Access Compliance Report

Public Rights-of-Way

(Curb Ramps)

Intersection ID: 16154	Main Street: LILAC_RD	Cross Street: PARK_RD	Location: SE
ADA ID: 0D0EACFE7639	Ramp Type: PerpDiag	Initial Pass/Fail: Fail	Overall Compliance: No
		Severity Score: 60

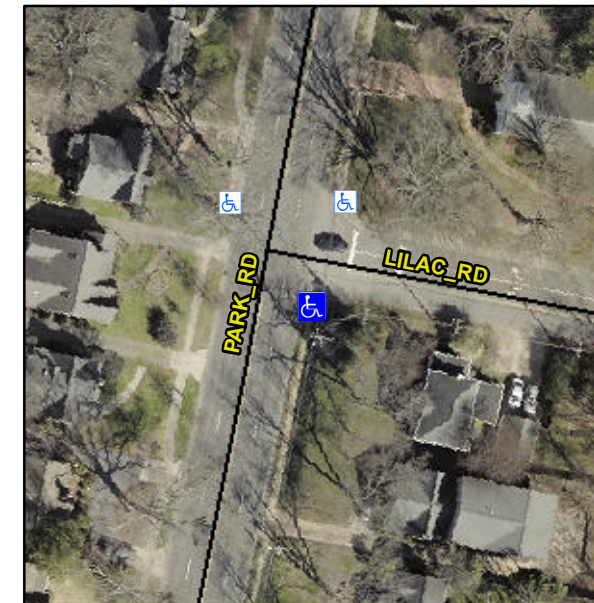
R304.5.1, R304.2.2, R304.5.3

Compliance	Description	Data	Compliance	Description	Data
N/A	Ramp Length (in)	61.0	No	Ramp Slope (%)	10.8
No	Ramp Width (in)	30.0	No	Ramp XSlope (%)	5.7
N/A	Flare Type LT	N/A	N/A	Flare Type RT	N/A
N/A	Flare Slope LT (%)	N/A	N/A	Flare Slope RT (%)	N/A
N/A	Flare Traversable LT?	N/A	N/A	Flare Traversable RT?	N/A
N/A	Landing Length (in)	N/A	N/A	DWS Provided?	N/A
N/A	Landing Width (in)	N/A	N/A	DWS Contrast?	N/A
N/A	Landing Slope (%)	N/A	N/A	DWS Length (in)	N/A
N/A	Landing X Slope (%)	N/A	N/A	DWS Full Width?	N/A
N/A	Landing Curb? (Y/N)	N/A	N/A	DWS Offset (in)	N/A
N/A	Shared Landing?	N/A			
N/A	Gutter Ponding?	N/A	N/A	Gutter Slope (%)	N/A
N/A	Gutter Lip Ht (in)	N/A	N/A	Gutter X Slope (%)	N/A
N/A	Painted X Walk1?	No	N/A	Painted X Walk2?	No
	X Walk 1 Direction	To NE		X Walk 2 Direction	To NW
N/A	X Walk 1 Width (in)	N/A	N/A	X Walk 2 Width (in)	N/A
	X Walk 1 Slope (%)	0.7		X Walk 2 Slope (%)	0.1
	X Walk 1 X Slope (%)	4.1		X Walk 2 X Slope (%)	1.2

Remove & Replace Curb Ramp With Two New Directional Ramps or Equivalent.
